7 May 2010

CU Bookstore Renovation, PR005322

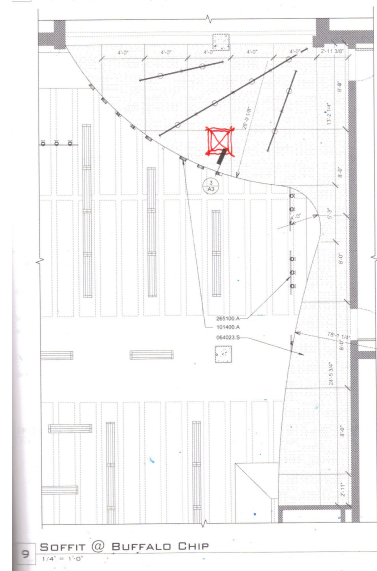
- 6 The steel angle support for the stone re: 4/A8 shall be 4x4x1/4, and shall be attached to the cold-formed metal framing in the adjacent wall with one screw at each stud location. Screws shall be stainless steel drill screws for steel studs and shall penetrate steel stud flange with not less than three exposed threads. See elevation drawing below.
